Subject: MHI's Response to US-APWR DCD RAI No.792-5928 Revision 3 (SRP 18)

Response to Request for Additional Information
No. 792-5928, Revision 3

RAI NO.: NO. 792 COLP 5928 REVISION 3
SRP SECTION: 18 - HUMAN FACTORS ENGINEERING
APPLICATION SECTION: 18.5- STAFFING AND QUALIFICATIONS
DATE OF RAI ISSUE: 7/26/2011

QUESTION NO.: 18-140

Figure 18.1-2 Operations Personnel Staffing and Organization (Minimum)

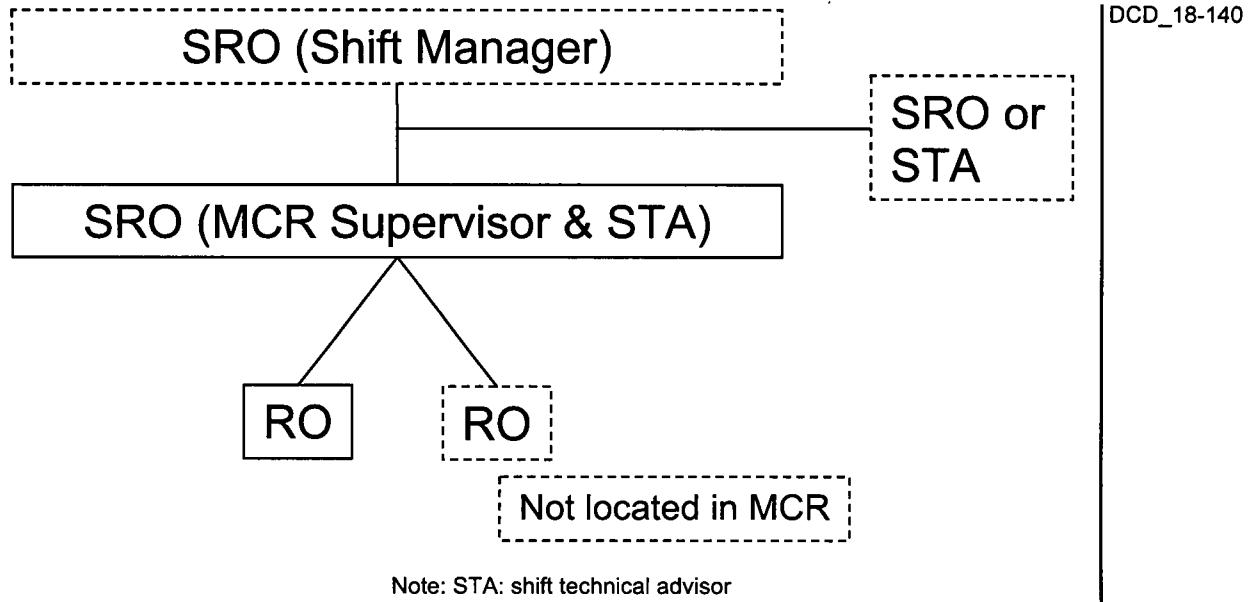
The response with regard to the role(s) of the SRO/STA, the staff finds the response does not provide sufficient information to address the staff concerns. The Shift Supervisor and STA responsibilities are not sufficiently defined for abnormal control room operations so that the staff can be assured the SRO/ STA working in the dual role will be able to successfully perform both duties. The staff requests additional justification describing how the Shift Supervisor will be able to perform the functions of the STA (as described in Generic Letter 79-61); and show that he is capable of all other concurrent duties during accident conditions such as interim site emergency director, communicating with the off-site organizations, company organizations, etc., while maintaining vigilance on the emergency plan which is in constant need of evaluation during an accident. Additionally, the shift supervisor, will likely be filling the interim site emergency director role for greater than one hour during the initial implementation of the emergency plan; until the emergency response organization is manned and he is relieved as emergency director. Explain how he can provide insight to the operating crew as STA during this time.

In consideration of staff comments, and for consistency with IN 93-81 and GL 79-61, and consistency with US practices in current operating plants, the minimum operator staffing levels for the US-APWR will be changed as follows:

- 1 SRO located at the plant fulfilling the role of Shift Manager
 - The combined role with STA will be deleted, to avoid concurrent duties during emergency conditions. The position name of Shift Supervisor will be changed to Shift Manager for consistency with operating plants and to avoid confusion with MCR Supervisor. The MCR Supervisor reports to the Shift Manager.

- 1 SRO located within the MCR fulfilling the role of MCR Supervisor and STA
 - The STA responsibilities will be assigned to the MCR Supervisor for normal operations (abnormal conditions are discussed below). To fulfill this role the MCR Supervisor will have both SRO and STA qualifications. This combined role is consistent with IN 93-81 which emphasizes "the need for engineering expertise in the control room" and "the STA will have an active role in shift activities". This is also consistent with many operating plants in the US. It is noted that in some US-APWR documents the MCR Supervisor is also referred to as the Shift Supervisor or Control Room Supervisor. Erroneous references to Shift Supervisor will be changed to Shift Manager.

- 1 additional SRO or STA at the plant
 - This is a new position, not previously described. This person, with either of these qualifications, will relieve the MCR Supervisor of his combined SRO/STA duties, allowing a single focus during emergency conditions. This will place a separate MCR Supervisor and STA in the MCR during emergency conditions. Since this new person is required to be at the plant, but not continuously in the MCR, this person can be shared by multiple units.

- 1 RO located at the controls of the plant in the MCR
 - No change
- 1 RO located at the plant
 - No change
